# PSP 1082 & 1085

# Mt Atkinson & Tarneit Plains

September 2016

This submission is made on behalf of the Victorian Planning Authority (VPA).

Figure 1. Plan of property from Plan 3 - FUS

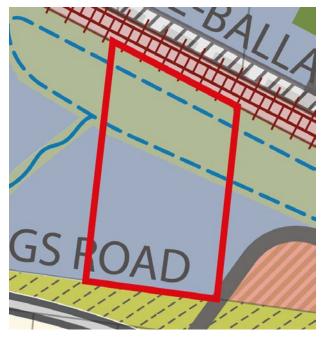
Mr Nesci submits that the value of the property will be reduced due to the proposed Industrial Zoning of the land. The submitter requests a review of the planning scheme and as a minimum, the rezoning of their property to either residential or mixed use.

The property in question was designated for industrial use in the West Growth Corridor Plan (2012), due to its location with good access along an arterial road and adjacent to the rail corridor and future OMR.

The Growth Corridor Plans set the strategic direction for future urban development in Melbourne's growth areas, including the provision for a 30-40 years supply of industrial

land based on anticipated future demand for industrial land. While there is ongoing pressure from land-owners to develop land for other purposes it is important that the state protects the land designated for industrial purposes as the provision of industrial land remains important for the provision of traditional manufacturing uses, new advanced manufacturing and for the expected increased activity in the transport and logistics sector. Plan Melbourne (2014) has also identified the Mt Atkinson PSP as a State Significant Industrial Precinct.

Figure 2. Plan of property from Plan 3 - FUS

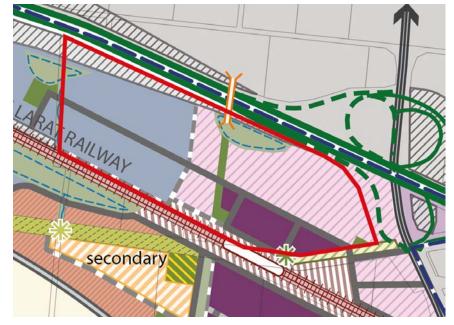
The detail of the site access to Meskos Road and Hopkins Road is still being finalised.

Expert evidence has been provided by MSA, the VPA and Melton City Council. Further detail is required to establish the scale of development to be

serviced, the scale of development to be funded through the ICP and to establish proof the conceptual plans developed to date can be delivered.

Figure 6. Plan of property from Plan 3 - FUS

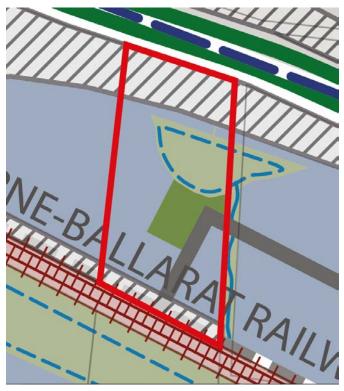
The location of credited open space on the subject site is not viable. Its location at the termination of a Connector Road restricts access to properties to the west. The park should be located within activity centre to east rather than an industrial area. The park has a reduced walkable catchment because of the OMR to north and railway to south. Park abuts a retarding basin, we contend that with landscaping and paths the retarding basin would provide suitable amenity and remove the need for the park. Recommend the park be relocated to the east at boundary of industrial area and town centre.

The Precinct Structure Planning Guidelines which have been put in place to assist in the development of PSPs sets a standard of approximately 2% of developable land within employment areas being identified as public open space. This open space contributes towards achievement of this standard in the PSP.

Plan 7 (Open Space) of the PSP establishes the walking catchment of 400m from local parks. The current configuration of open space north of the rail corridor provides a local park within 400m of the majority of the land north of the rail corridor. Moving this open space to the east would reduce the amount of land within 400m of a local park.

The proposed park abuts a retarding basin. The retarding basin could be designed in such a way to provide amenity relief to the industrial area together with edge treatments such as footpaths, furniture and street planting.

It is vital that the land set aside for local parks is not encumbered by drainage assets to ensure that the uses established in Appendix I of the PSP (Open Space Delivery Guidelines) can be delivered. The PSPlanning Guidelines also state the local parks should be efficiently designed to maximise integration and sharing of space with publicly accessible encumbered land. When considering the delivery of open space, R42 of the PSP should be considered to ensure that the open space delivers the best design outcomes for the subdivision.

Figure 8. Plan of property from Plan 3 - FUS

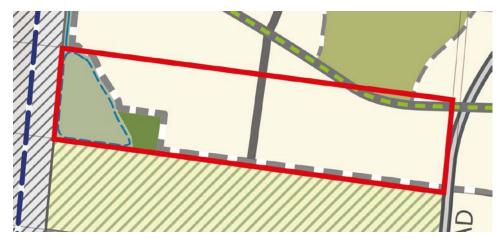
Conservation Area 7 – The Conservation Management Plan has implications to developable land on our property to the north.

Request removal of note at Section 11 "All necessary fire breaks must be located outside the conservation area" and all other related requirements in the PSP be removed to clarify that fire management of the conservation areas occur within the conservation areas.

It is acknowledged that a one sided road may add to construction costs. The local access road abutting the southern property will be delivered by the developer as required to service development.

The PSP establishes through the Concept Plan for Conservation Area 7 a conservation area interface zone. The Biodiversity Conservation Strategy Guidelines establishes principles for fire management within the interface. These guidelines are provided in the Concept Plan for Conservation Area 7. The PSP also establishes through the cross sections for roads abutting the conservation reserve buffers to ensure no inappropriate tree planting occurs, along with a buffer in which no structures can be built.

The Concept Plan for Conservation Area 7 identifies low fencing to be used that appropriately protects the biodiversity values of the conservation area. R44 of the PSP also requires that where fencing of open space is required, it must be low scale and /or visually permeable to facilitate public safety and surveillance.

Figure 10. Quarry Buffers

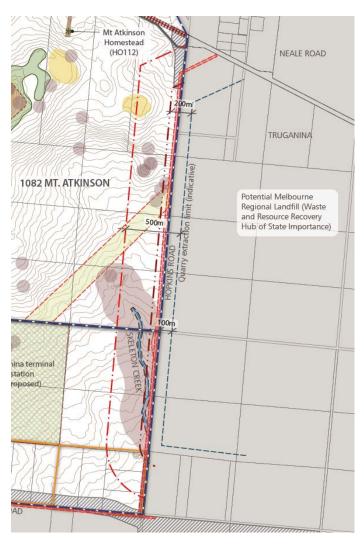
Specific Provisions - Referral of planning, subdivision and building and works applications - Ravenhall Quarry. Modify this clause to refer to the 'quarry blast buffer 'only and remove reference to the quarry sensitive use buffer.

The PSP specifies the quarry sensitive use buffer as per the separation distance outlined in EPA's Publication 1518 Recommended Separation Distances for Industrial Residual Air Emissions and prohibits sensitive uses within this area. Refer attached updated draft schedule to reflect quarry issues. The 200m blast buffer is a buffer for no buildings and structures and 200m has been requested by DEDJTR (since Growth Corridor Plans) based on risk-based calculations relating to maximum distance flyrock could travel when blasting).

The EPA has recently confirmed that it concurs with the quarry buffers proposed in the PSP.

Figure 11. Plan of property from Plan 3 - FUS

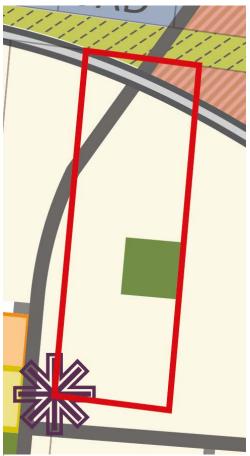
The location of local park 'OS14' with regard to the centrality to its catchment. The PSP identifies a 1ha park on Property 31 - the park is not centrally located to a catchment defined by a 400m radius. The western catchment of the park has significant overlap. The radius excludes an area to the south as being more than 400m from centre of the catchment. OS14 doesn't optimise accessibility to open space and heavily burdens Property 31. Propose relocation to Property 32, this would provide a better distribution of open space and Property 32 forms part of a larger development site, ameliorating the impacts on NDA.

Open Space 14 as identified on Plan 7 (Open Space) of the Precinct Structure Plan (PSP) is located to give consideration to the open space provision of the Mt Atkinson Volcanic Reserve. The volcanic reserve will provide active open space and provide a local park facility in the northern part of the reserve (see Figure 1- Mt

Atkinson Volcanic Cone Reserve of the PSP). Moving Open Space 14 to the south east as suggested in the submission would result in an overlap of local park provision between OS14 and the Mt Atkinson Volcanic Cone Reserve.
